Final Decision Type II Staff Report

File number(s): DR 21-06 & EXCP 21-02
Related files: PLA 2020-04
Project name: Parr Road Water Well
Date of decision: June 21, 2021
Date of mailing: June 22, 2021
Applicant: Eric Liljequist, P.E., Public Works Projects & Engineering Director
Landowner: City of Woodburn
Site location: 900 Parr Road
Tax Lot(s): 052W130000700

Summary:

Figure 3.01D – Service Collector

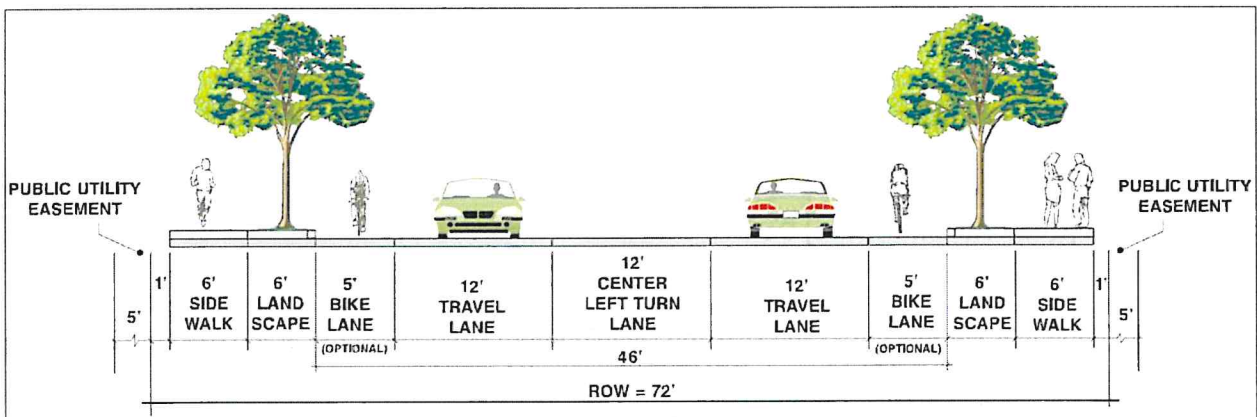
Comparing the existing conditions to Figure 3.01D, missing half-street improvements include the bike lane, 6-ft landscape strip, and 6-ft buffered sidewalk. The applicant's narrative on page 4 states:

The applicant is requesting to maintain the existing configuration of improvements. Staff accepts the applicant's request because the existing conditions provide adequate pedestrian and bicycle facilities with a row existing street trees on the south side. The existing paved area of the street already provides for the vehicular needs illustrated in the cross-section. Staff adds *Condition of Approval EXCP-1* to dedicate half of the ROW deficit (appears to be 6ft).

EXCP-1. Right-of-Way (ROW): Applicant shall dedicate ROW along Parr Road equal to half of the deficit needed to achieve the planned width of a Service Collector street. Existing ROW appears to be 60ft, Figure 3.01D calls for 72ft of ROW, resulting in a 12ft deficit. Half the deficit would therefore be 6ft. This is due prior to building permit final inspection.

Figure 1:
Site Plan

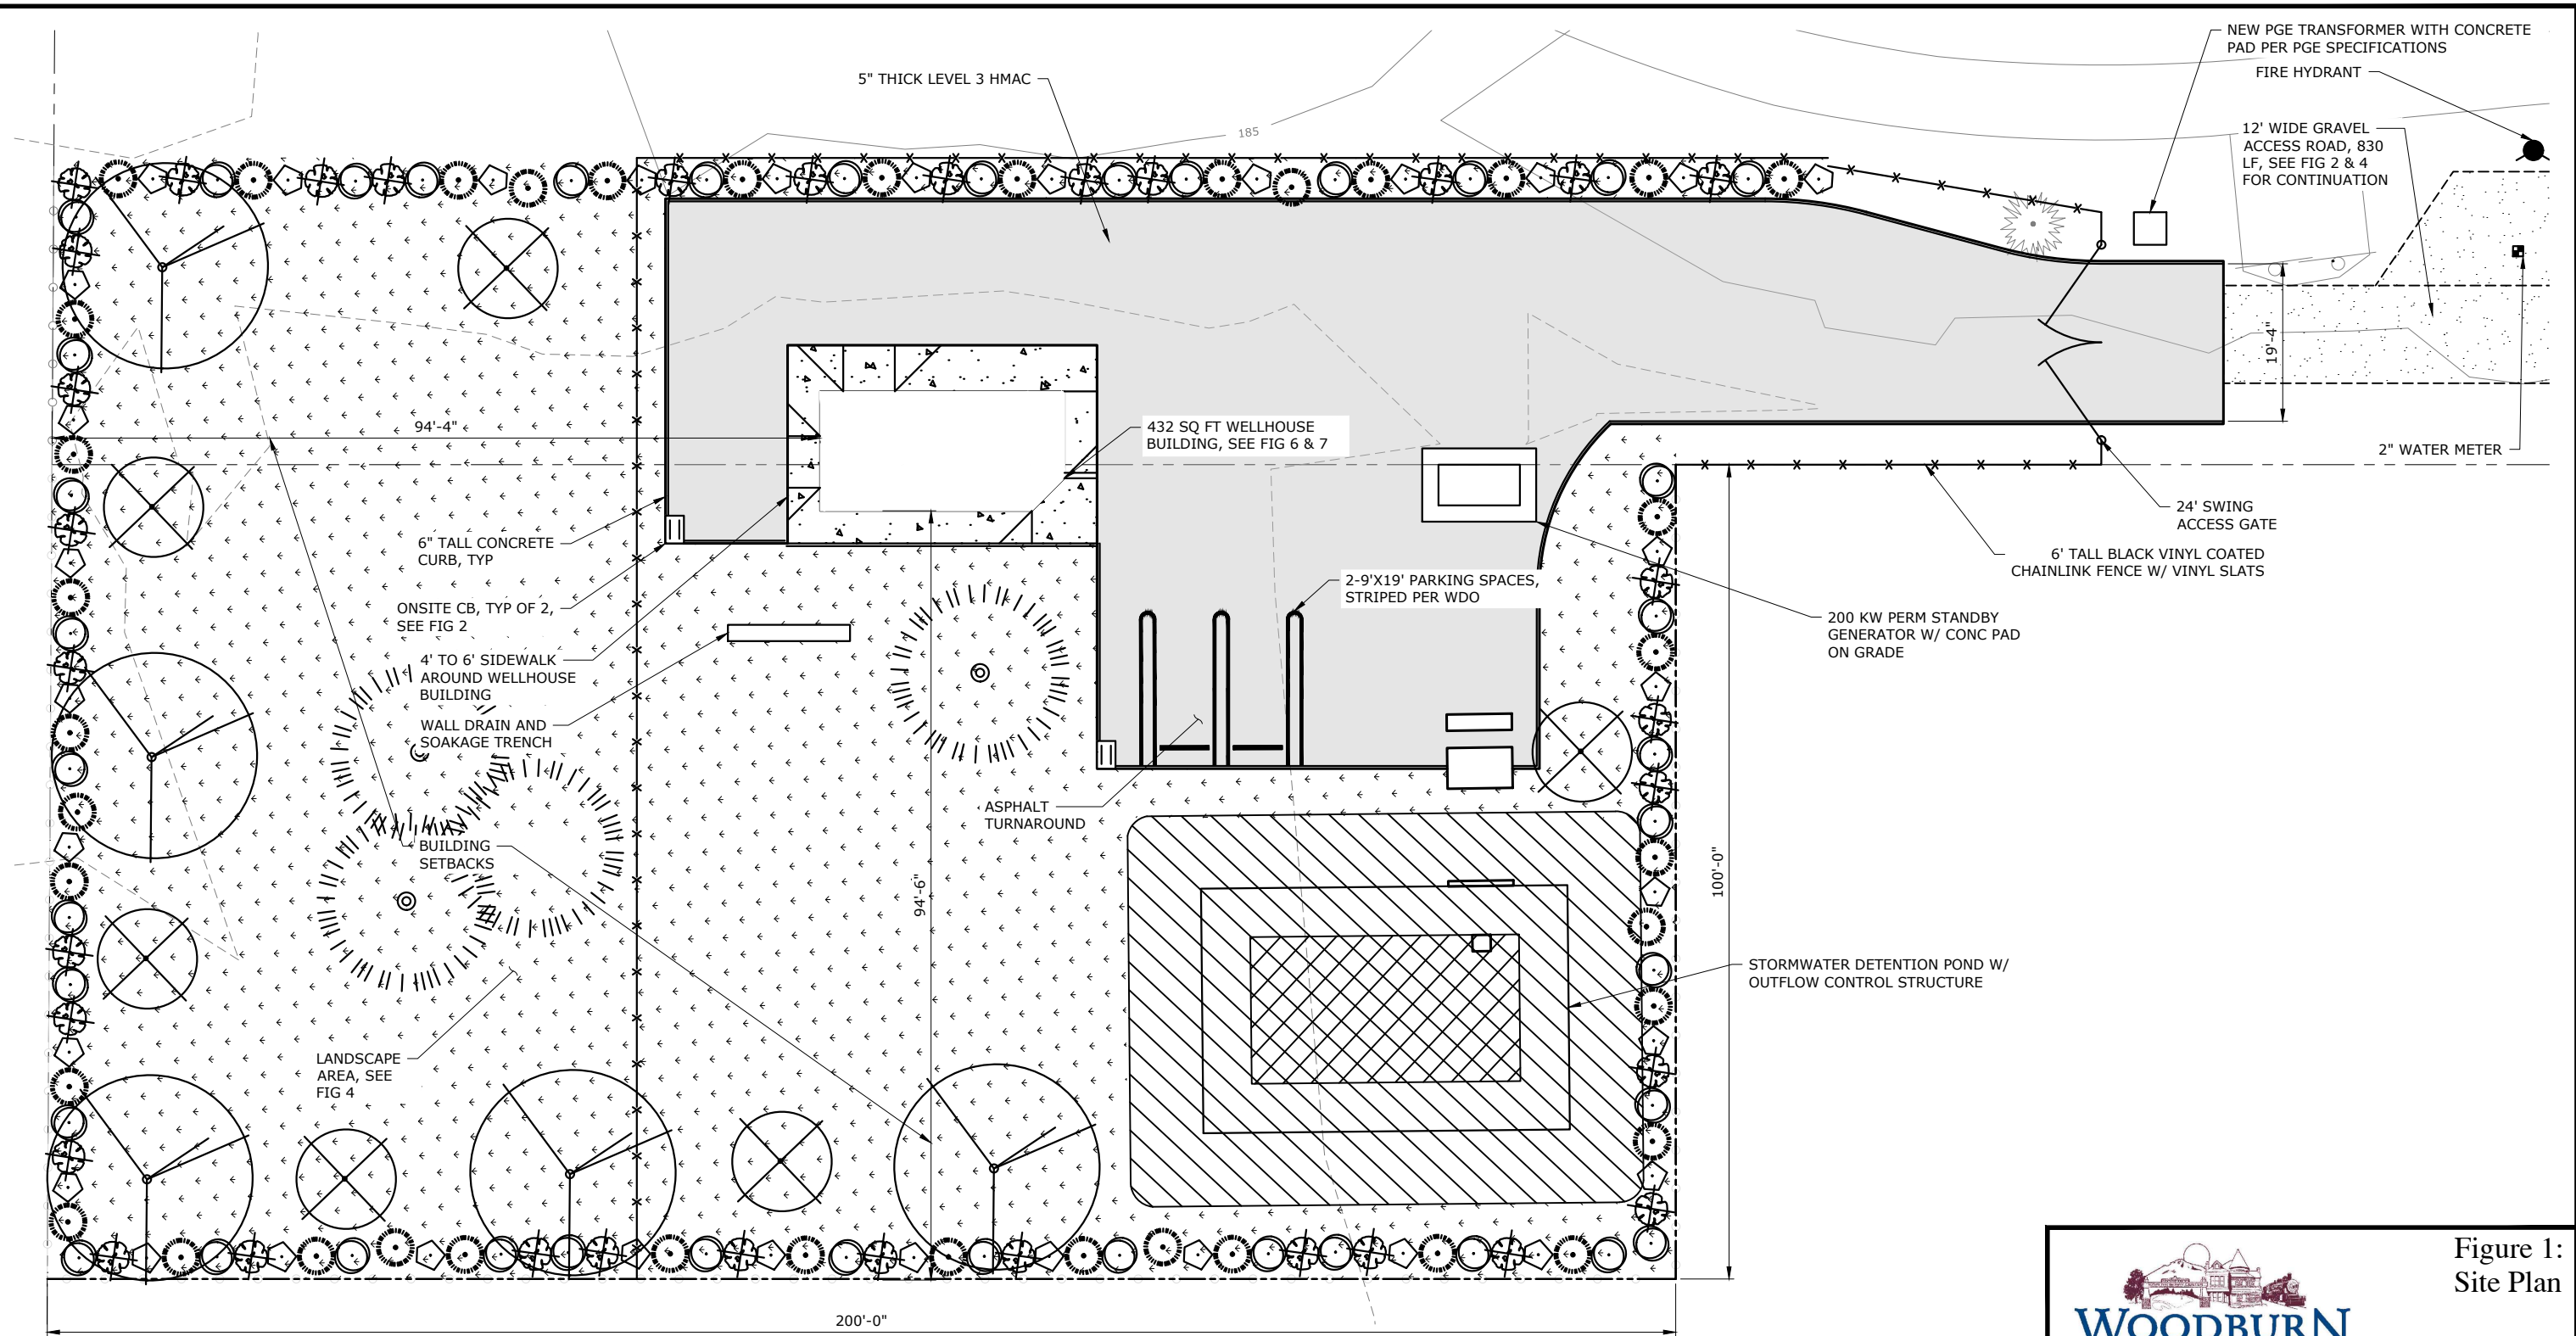
DR-1. Driveway: Applicant shall revise plans to illustrate and note the 12ft access road paved to the standard outlined in WDO 3.04.04. This is due prior to building permit issuance.

The proposal includes adding a 12ft wide gravel access road along the east property line and new asphalt pavement around the wellhouse building. Staff adds *Condition of Approval DR-1* to revise the gravel access road to be paved per this standard.

Figure 4:
Landscape Plan

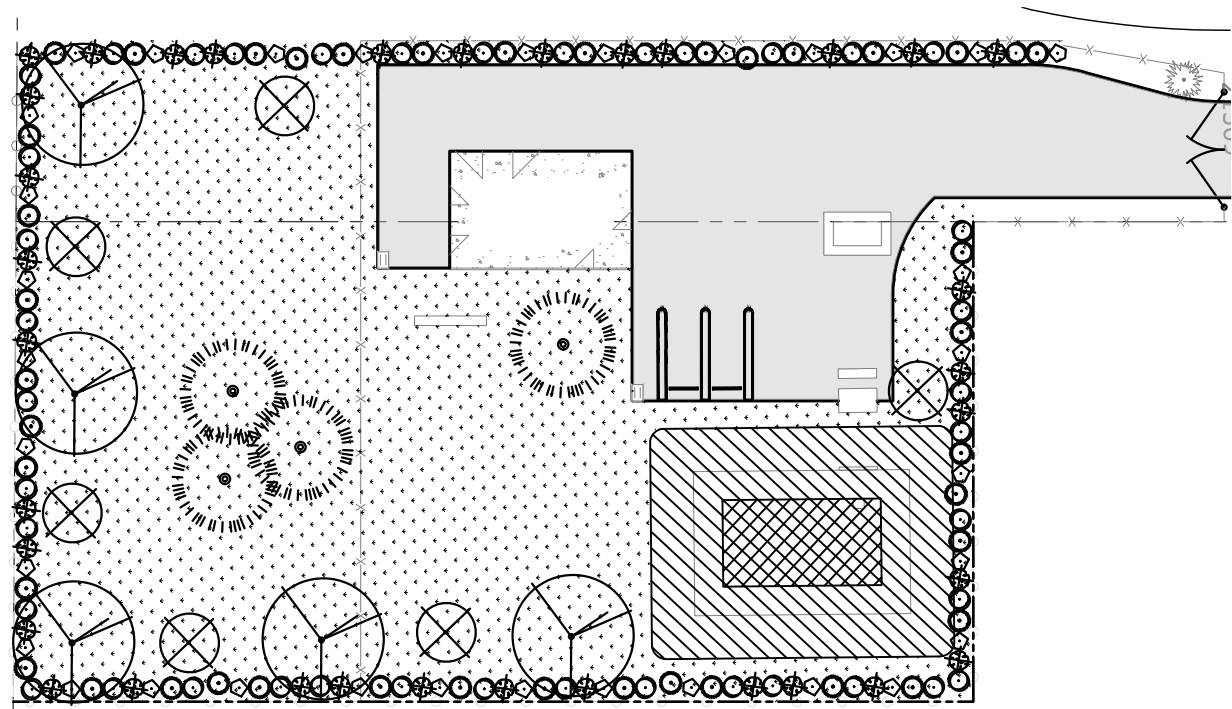
The landscape plan tabulates the Plant Unit (PU) requirement per Table 3.06B and provides a planting schedule for the proposed landscaping per Table 3.06C. The PU tabulation incorrectly assumes the only applicable yard type is the “Other yards” category. In fact, there are two applicable yard types:

- “Off-street parking and loading areas” is based on 20% of the total paved surface area at a planting ratio of 1 PU per 20 sq ft. Staff estimates this to be 68 sq ft (20% of the area of two parking stalls), equating to 17 PUs required; and
- “Other yards” accounts for all other landscaping areas, which the landscape plan tabulation already indicates as 400 PUs required.

The incorrect PU tabulation is irrelevant because the proposal provides 786 PUs, well in excess of the 400 PUs required (Footnote 2 of Table 3.06A allows the landscaping in the other yard types to account for the off-street parking and loading areas requirement).
